**1995 Protege  
Airbag System  
[Special Service Program - SSP 26]**

**SUBJECT:** **Special Service Program – SSP26**  
1995 Protege - Airbag System

Fig.-1

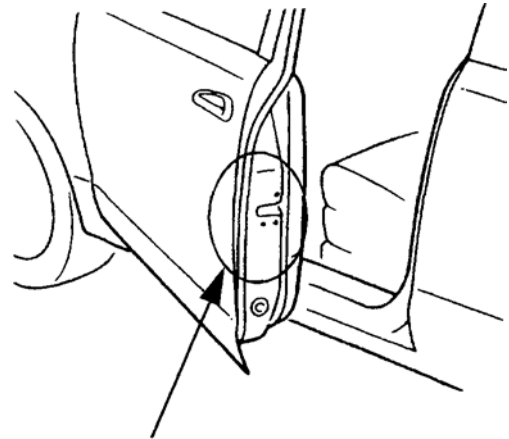
2. Perform a **Warranty Vehicle Inquiry** using your **MDCS System** and inspect vehicle for an Authorized Modification Label **SSP26** attached to the drivers side door. Refer to illustration.

Inspect This Area For SSP26 Label

1. Install Authorized Modification Label on driver's side door. Refer to Fig. 1.

Fig. 2

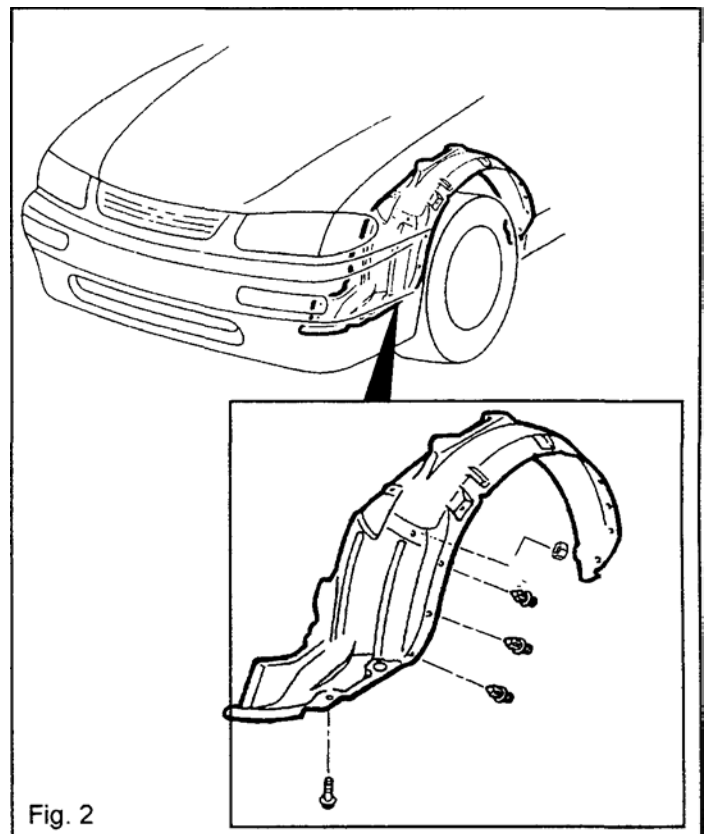
1. Lift the vehicle on a hoist.
2. Remove the parts listed below and slide the front portion of the outer wheel well downward. Refer to Fig. 2.

Fasteners (3)  
Bolt (1)  
Nut (1)

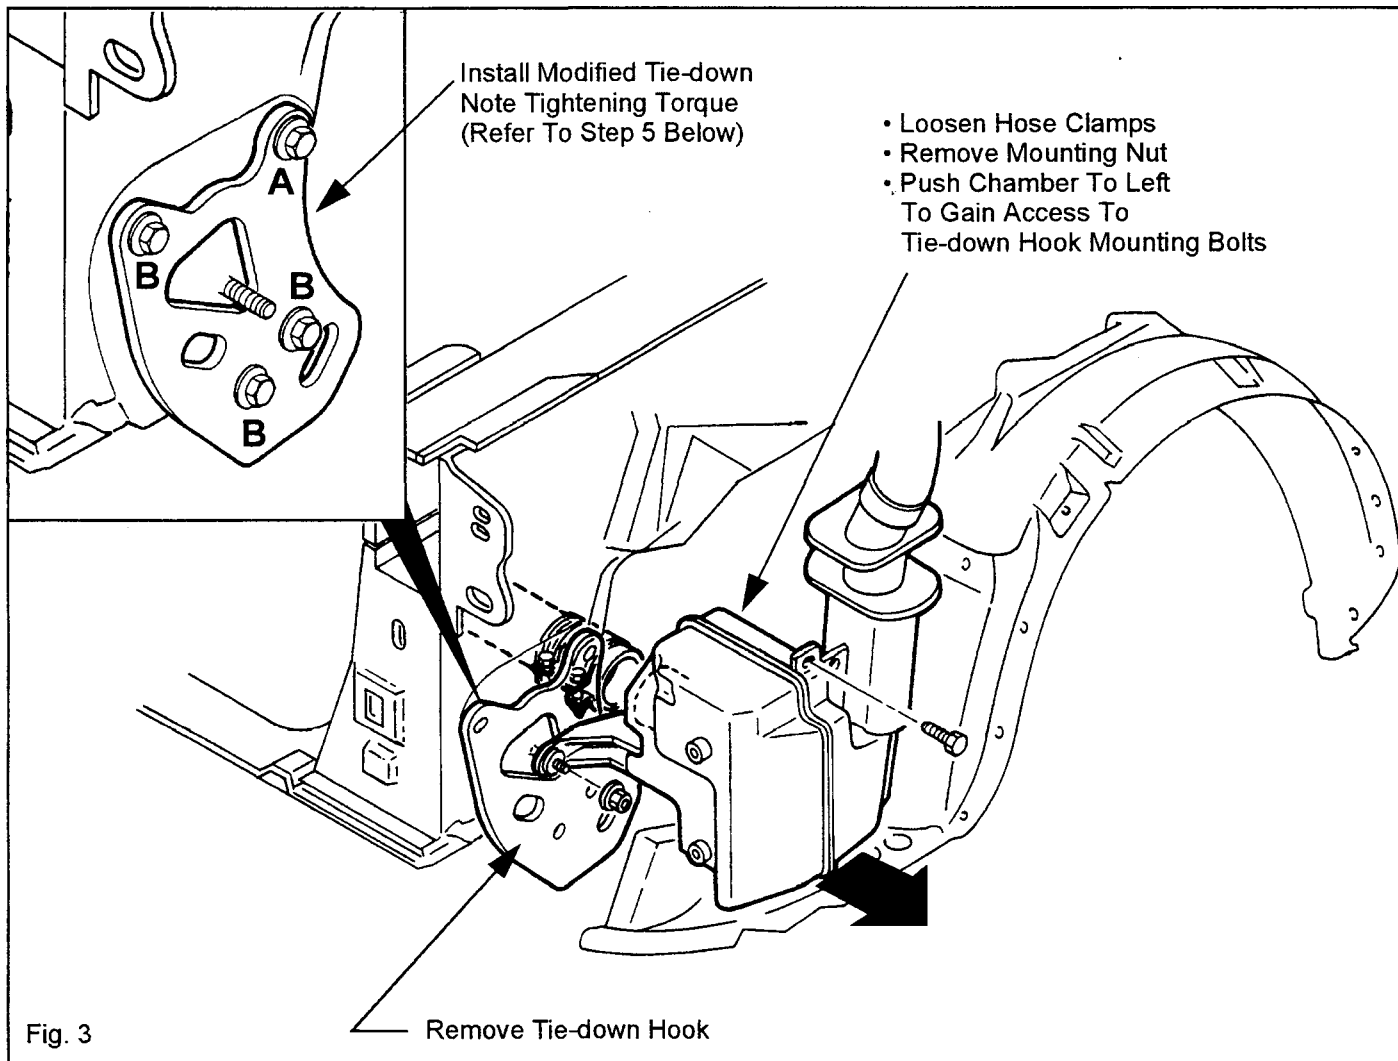
3. Remove the resonance chamber mounting nut and move the chamber to the left side of the vehicle.
4. Remove the four (4) tie-down hook bolts (left side) and remove the tie-down hook.
5. Install the modified tie-down hook (p/n BC1D 53 364ATT). Refer to Fig. 3 **Tightening Torque Bolt "A":** 4.4 - 6.9 kgf-m (32 - 50 ft-lbs)  
**Tightening Torque Bolts "B"** 3.7 - 5.5 kgf-m (27 - 39 ft-lbs)

Fig. 4

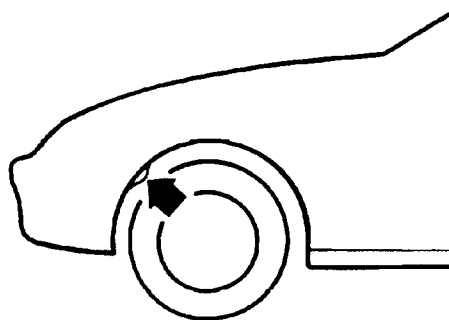
Outer Wheel Well Should Not Exceed From Fender

6. Install resonance chamber and outer wheel well.  
**NOTE:** Install outer wheel well along fender, do not allow to extend past fender. Refer to Fig. 4
7. Remove and replace tie-down hook on right side.
